# Access Compliance Report

## Public Rights-of-Way

### (Curb Ramps)

Intersection ID: 9801	Main Street: ETHEL_GUEST_LN	Cross Street: RISING_OAK_DR	Location:	NW
ADA ID: 09E47C4FC488	Ramp Type: PerpDiag	Initial Pass/Fail: Fail	Overall Compliance: No	Severity Score: 35
Codes/Mitigation Info/Possible Solution		Field Measurements/Component Compliance

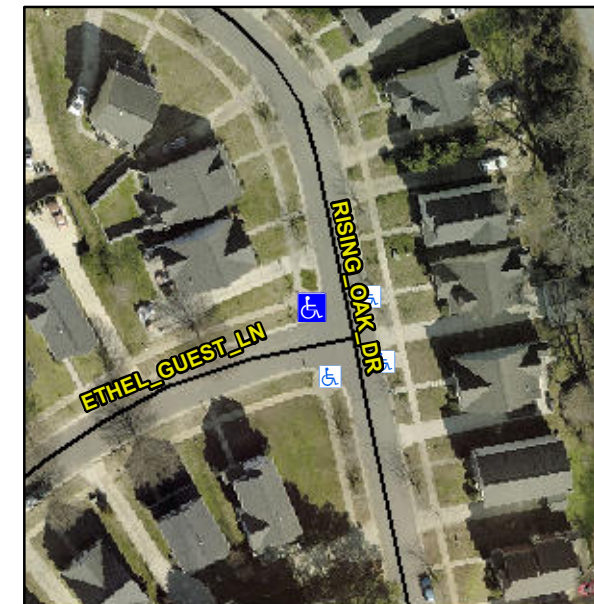
**Not Found, R304.5.1**

Compliance	Description	Data	Compliance	Description	Data
N/A	Ramp Length (in)	94.5	Yes	Ramp Slope (%)	5.7
No	Ramp Width (in)	30.0	Yes	Ramp XSlope (%)	0.9
N/A	Flare Type LT	N/A	N/A	Flare Type RT	N/A
N/A	Flare Slope LT (%)	N/A	N/A	Flare Slope RT (%)	N/A
N/A	Flare Traversable LT?	N/A	N/A	Flare Traversable RT?	N/A
N/A	Landing Length (in)	N/A	N/A	DWS Provided?	N/A
N/A	Landing Width (in)	N/A	N/A	DWS Contrast?	N/A
N/A	Landing Slope (%)	N/A	N/A	DWS Length (in)	N/A
N/A	Landing X Slope (%)	N/A	N/A	DWS Full Width?	N/A
N/A	Landing Curb? (Y/N)	N/A	N/A	DWS Offset (in)	N/A
N/A	Shared Landing?	N/A			
N/A	Gutter Ponding?	N/A	N/A	Gutter Slope (%)	N/A
N/A	Gutter Lip Ht (in)	0.5	N/A	Gutter X Slope (%)	N/A
N/A	Painted X Walk1?	No	N/A	Painted X Walk2?	No
	X Walk 1 Direction	To E		X Walk 2 Direction	To S
N/A	X Walk 1 Width (in)	N/A	N/A	X Walk 2 Width (in)	N/A
	X Walk 1 Slope (%)	2.9		X Walk 2 Slope (%)	2.8
	X Walk 1 X Slope (%)	1.6		X Walk 2 X Slope (%)	3.9

N/A	Ramp inside XWalk1?	N/A	N/A	Ramp inside XWalk2?	N/A
	Road Slope (%)	1.9	N/A	Clear Space?	N/A
	Road X Slope (%)	6.0	N/A	Clear Space to XWalk (in)	N/A
N/A	Any Obstructions?	N/A	N/A	Storm Grate/Utility Hazard?	N/A
	Obstruction Type			Storm Grate/Utility Type	
		N/A			N/A
		Yes		Surface Condition? (G/P)	Good

**Remove & Replace Curb Ramp With Two New Directional Ramps or Equivalent.**
